ADDRESS : 163 WILDWOOD WAY SUBDIV: CAROLINA SEASONS PH2 SECT 2 59
 CONTRACTOR : BILL CLARK HOMES LLC PHONE : (252) 355-5805
 OWNER : CRESTVIEW DEVELOPMENT LLC PHONE :
 PARCEL : 09-9567-03- -0006- -12-
 APPL NUMBER: 13-50032553 CP NEW RESIDENTIAL (SFD)
 DIRECTIONS : T/S: 12/10/2013 08:42 AM JBROCK ----
 CAROLINA SEASONS #69

Truss Fabricator: **R&D Thiel dba Carpenter Contractors of America**
Job Identification: **REPAIR / 43448-1D1 PBA;C -A1**
Truss Count: **1**
Model Code: **IRC**
Truss Criteria: **IRC2009/TPI-2007(STD)**
Engineering Software: **Alpine Software, Version 13.01.**
Minimum Design Loads: **Roof - 40.0 PSF @ 1.15 Duration**
Floor - N/A
Wind - 100 MPH ASCE 7-05 -Closed

TRUSS REPAIR

(43448-101 PMA.C - A1)

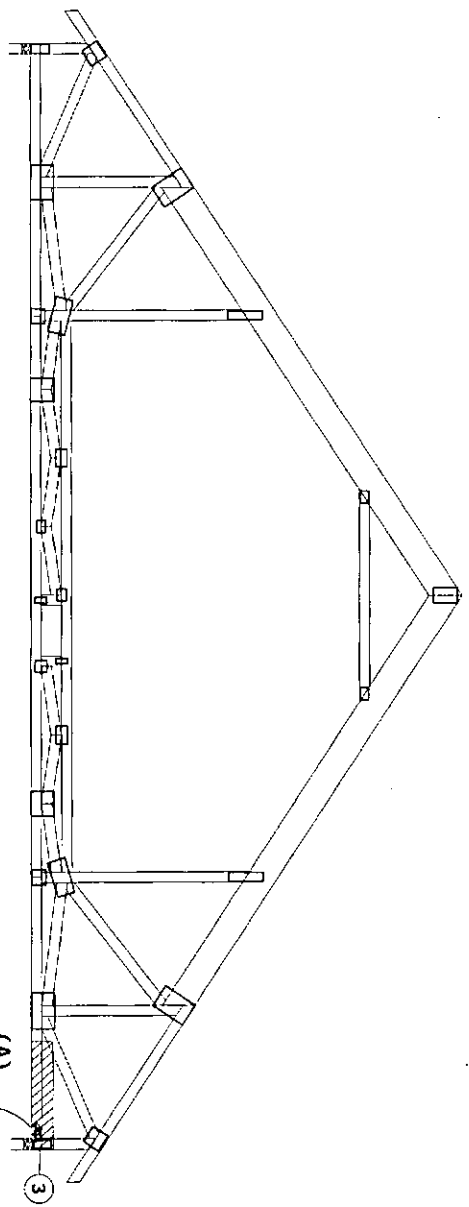
This truss is repaired for a damaged bottom chord (excessive wane) at right end of truss as shown. Refer to drawing R8976 13353020 for plates and other data not given here.

EXCESSIVE WANES ON
 BOTTOM CHORD NEAR
 RIGHT END OF TRUSS
 0-10-8
 R=2333 U=309 W=3.5"

(A) (2) 2X8X 3-0-0 SP #2 12A SCAB; ATTACH ONE SCAB TO EACH FACE OF TRUSS WITH 10d BOX (0.128"X3.0") NAILS @ 4"OC, PLUS A CLUSTER OF (3) NAILS IN RIGHT END VERTICAL WITHOUT SPLITTING LUMBER.
